FINAL
ENVIRONMENTAL IMPACT STATEMENT

URS Corporation
1421 Chapala Street
Santa Barbara, California 93101

This is a programmatic environmental impact statement (EIS) for adoption of the proposed Mineral Resource Management Plan (MRMP) for Vandenberg Air Force Base (VAFB).

Figure 3.2-1A
WATER WELL LOCATIONS

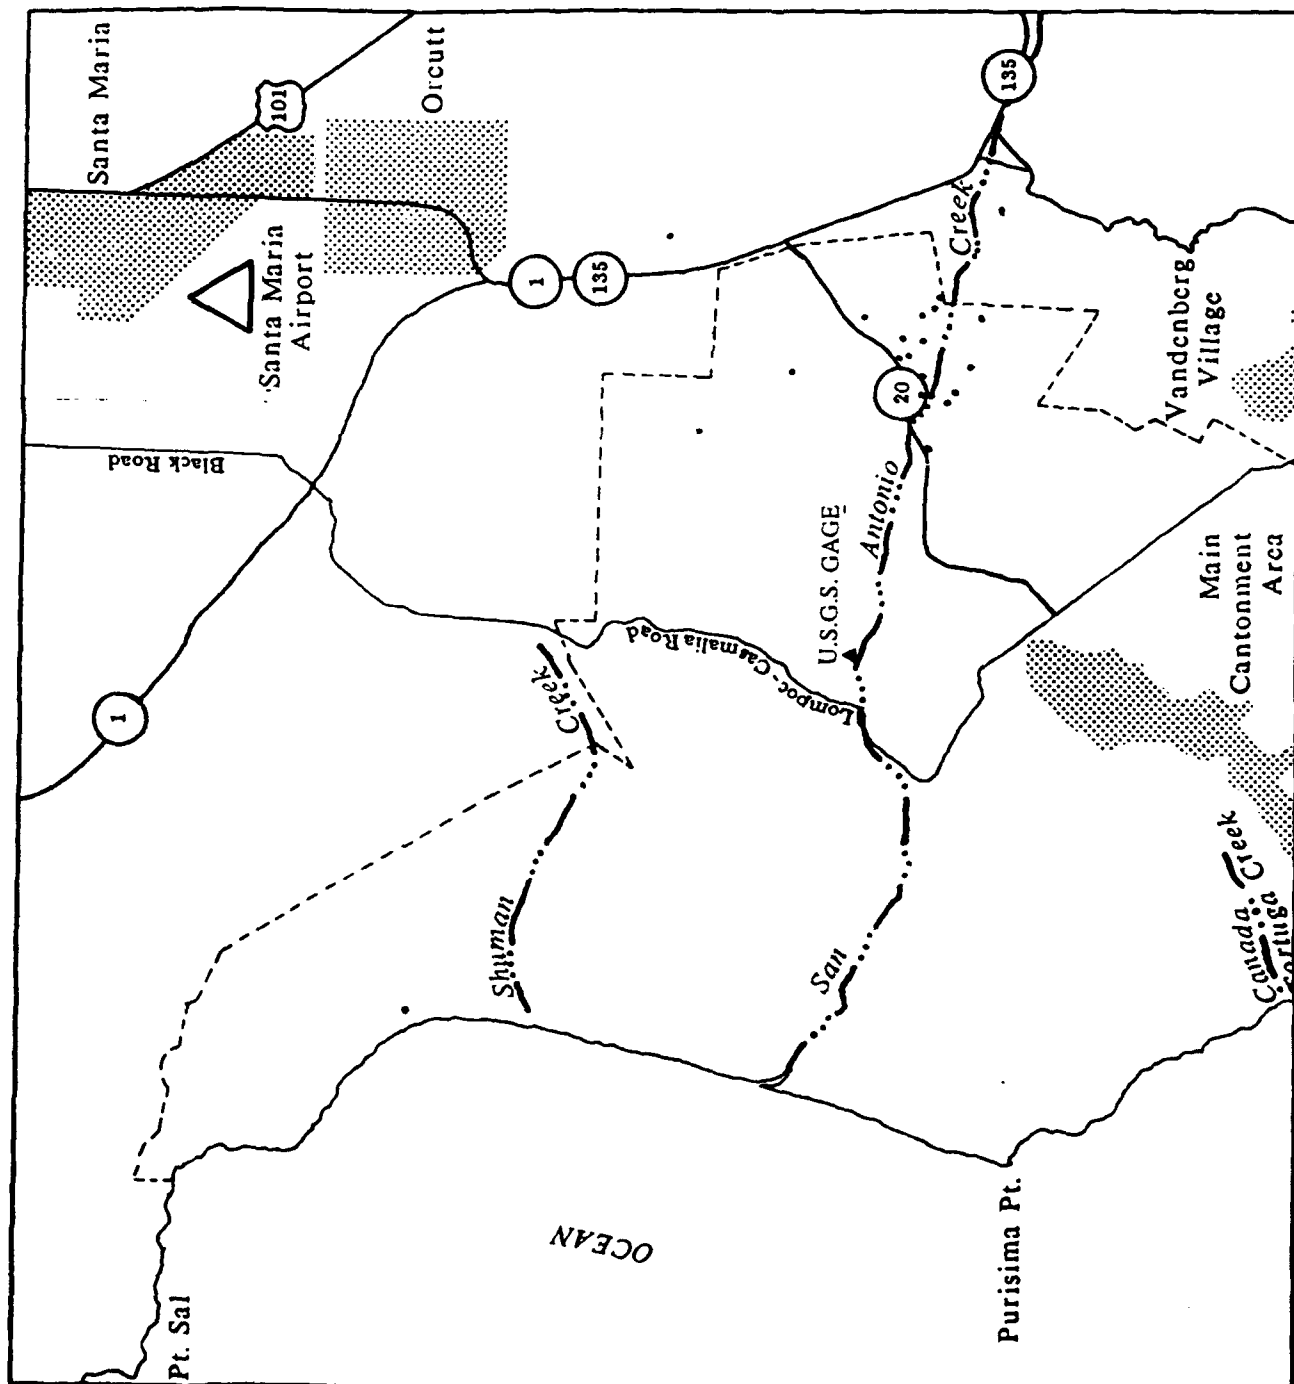
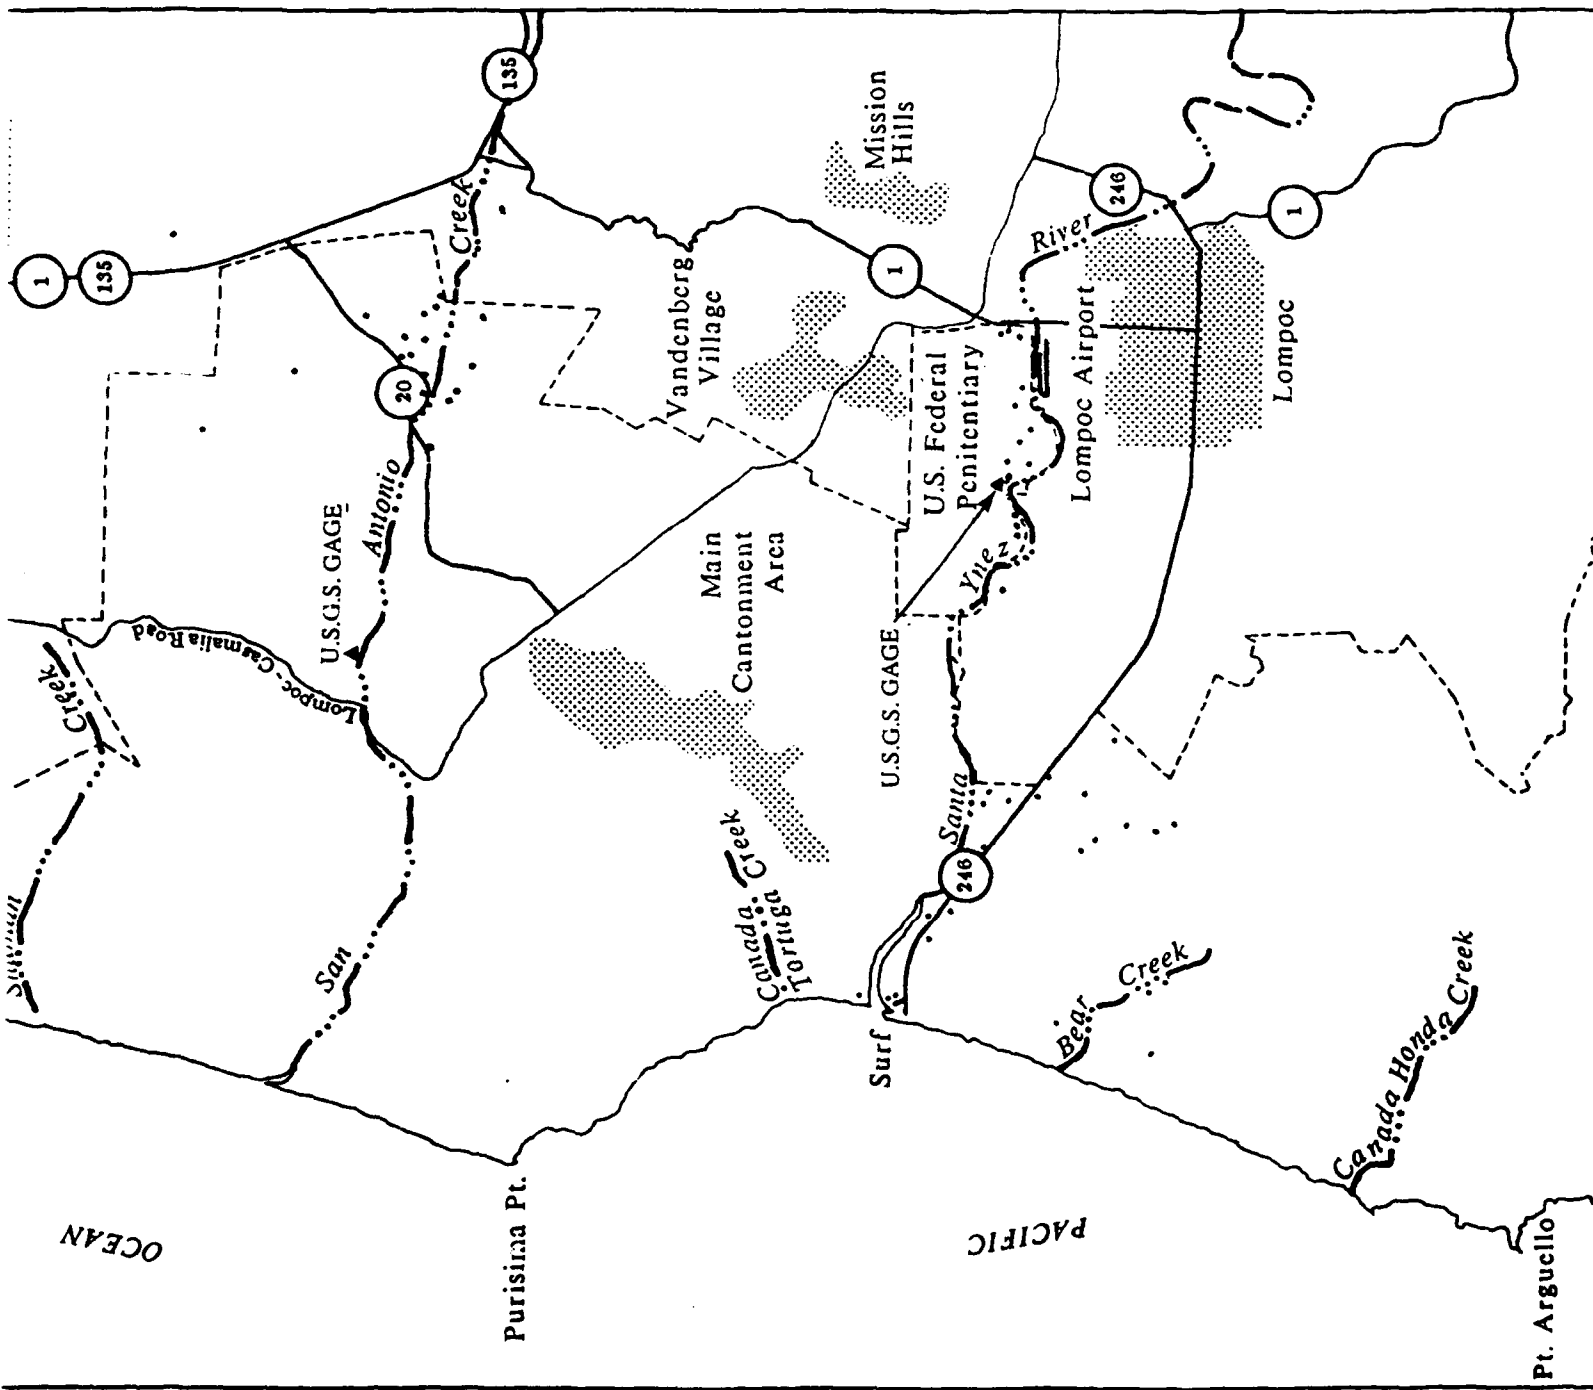
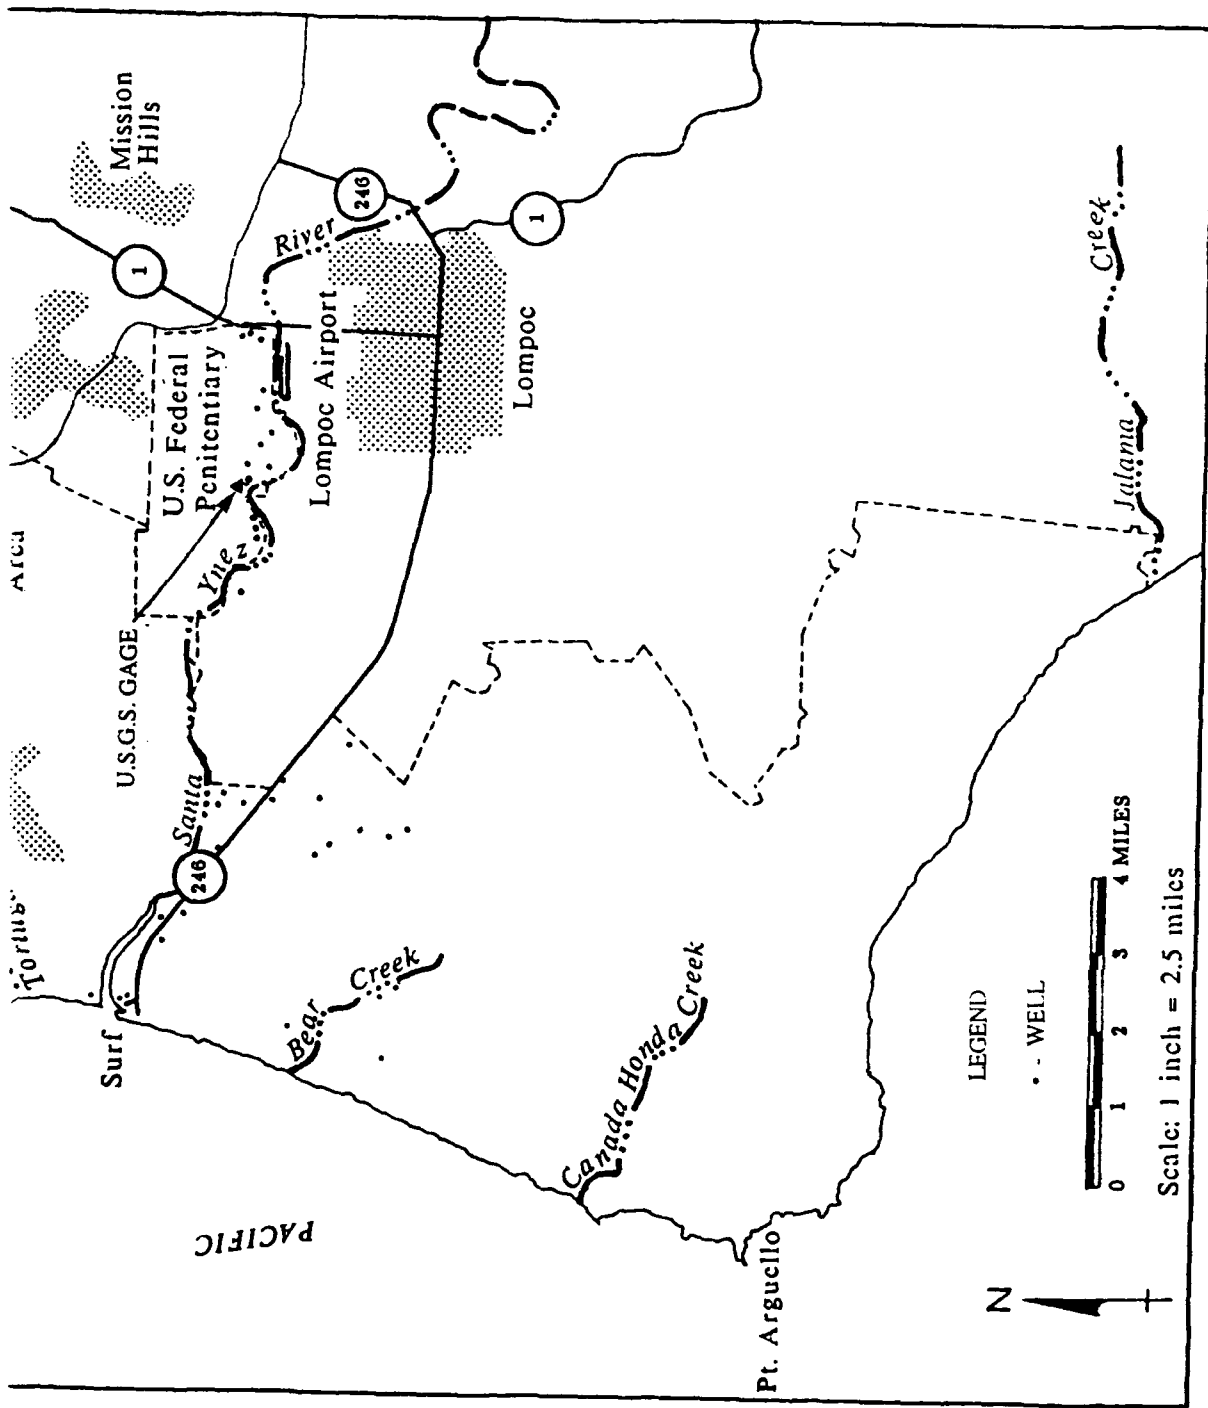
Section 3.2.4.1.2; page 3.2-8, add the following sentence at the end of paragraph one: "Water well locations are shown in Figure 3.2-1A." See the attached figure.

WQCB-5 Surface water and groundwater features are delineated in figures 3.2-1 and 3.2-2 of the DEIS, respectively. Water well locations are displayed on a new figure (Figure 3.2-1A of the errata for the EIS).

Figure 3.3-2
SANTA BARBARA COUNTY AIR QUALITY
MANAGEMENT REGION

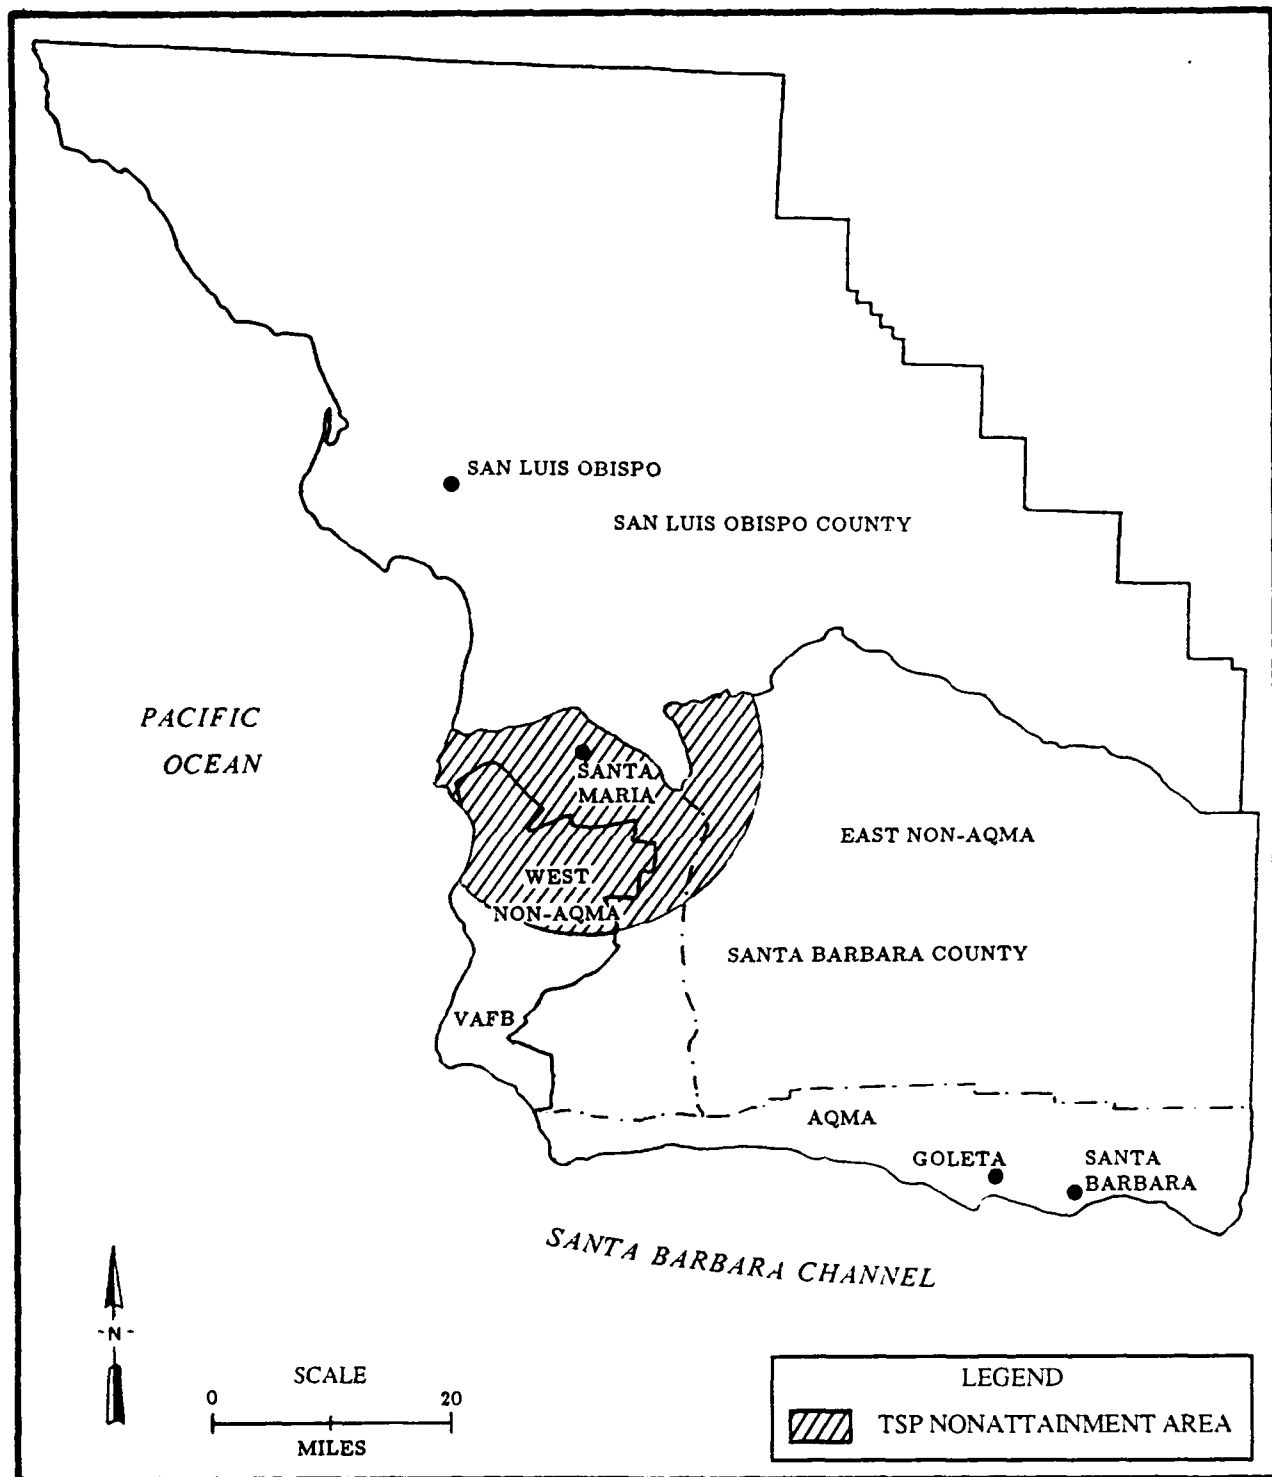
Page 3.3-9, the TSP nonattainment area in Figure 3.3-2 has been corrected to only include the 15-mile radius from Santa Maria that is within Santa Barbara County.

1. The TSP non-attainment area described on page 3.3-7 and depicted in Figure 3.3-2 mistakenly includes a portion of southern San Luis Obispo County. No areas in San Luis Obispo County are currently designated as Federal non-attainment areas for any pollutants. TSP measurements at Nipomo are well within Federal standards. The Nipomo monitoring station is located approximately nine miles north of Santa Maria. This correction should be noted in the FEIS.
